工程變更客戶通知單

Engineering Change Customer Notification

ECR/ECN 單號： ECR/ECN Number:	EO000275
日期： Date:	2024/09/27
變更者/郵箱： Author/Mail	Rita Lin
客戶端工程變更需求確認：(signature) EC request confirmation by customer	請於 10 工作日內簽回，若超過 10 日未簽回將視為同意此變更 Please sign back within 10 working days, if you do not sign back within 10 working days, you will be deemed to agree to this change.
客戶端工程變更完成確認：(signature) EC completion confirmation by customer	請於 10 工作日內簽回，若超過 10 日未簽回將視為已確認 Please sign back within 10 working days, if you do not sign back within 10 working days, it will be deemed as confirmed.

產品類別 Product Category	零件編號 Part Number
	CAB.0102

4. 變更圖例 Illustration of Change 變更前/Before

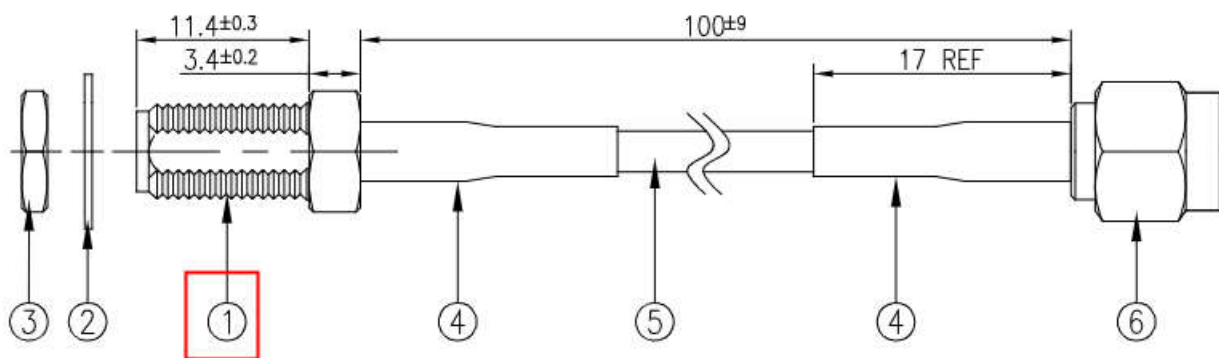
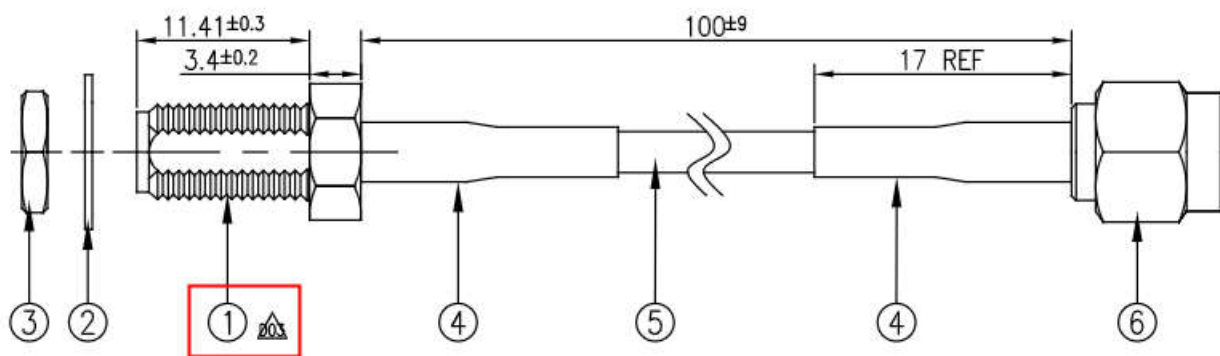
變更類型 Type of Change	☒ 工程設計變更 Engineering Design Change		☐ 生產製程變更 Production Process improvement
	☐ 其他:		
變更原因 Reason for change	The supplier phased off the original SMA(F) connector.		
變更說明 Description of Change	Change new part No. of the SMA(F) connector.		
變更影響 Impact of change	☐ 外觀 Appearance ☐ 功能 Function ☒ 規格 Specification ☐ 品質 Quality ☐ 可靠度 Reliability ☐ 法規 Regulations ☐ 包裝 Package: ☐ 其他 Others:		
	上述影響描述: Describe if above applies: Yes	SMA(F) connector part No. is changed.	
預估轉換日期 Forecast Estimated Transition Date	Last buy (old product)	running change	
	New buy (new product)	running change

Name	P/N	Material	Finish	QTY
20%	1 SMA(F)BK ST	200411G070013A	Brass	Au Plated	1
20%	2 Washer	200411G070013A	Brass	Au Plated	1
20%	3 Nut	200411G070013A	Brass	Au Plated	1
	4 Heat Shrink Tube	001315C020000A	PE	Black	2
	5 RG174 Coaxial Cable	301315C000000A	PVC	Black	1
20%	6 SMA(M)ST	200219K010000A	Brass	Au Plated	1
